PROPOSED REMODELING.
SMITH-WHITTIER BLOCK
DATE: 3/17/83
CHRISTOPHER GLASS, ARCHITECT
38 CHESTNUT ST. CAMDEN, MAINE 04843 207-236-8218
3/17/83

6

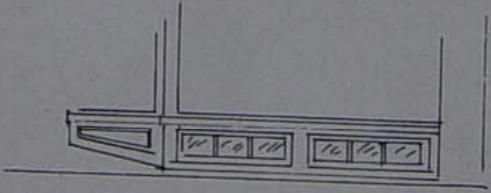
← CORNICE UNCHANGED

EXPOSE GRANITE PIER →

← EXPOSE GRANITE LINTEL

← BOX IN STEEL BEAM WITH WOOD-MOUNT SIGN ON WOOD BOX. NOTE: ONCE FACADE IS STRIPPED, DETAILS OF ENCLOSURE WILL BE DETERMINED

← EXPOSE GRANITE PIER

← NOTE: IT WOULD BE BEST TO RESTORE WOOD BASE WITH CELLAR WINDOWS BUT BRICK MAY REMAIN.

NOTE THAT PLATE GLASS IS HISTORICAL. BUILDING ORIGINALLY HAD SECOND GLAZED WALL ON INSIDE OF DISPLAY WINDOW. FOR INCREASED INSULATION, THAT MIGHT BE RESTORED →

↑ REMOVE BRICK BASES FROM POSTS. SHEATH POSTS IN WOOD TRIM

↑ ORIGINAL BASE SHOWN IN DRAWING BELOW
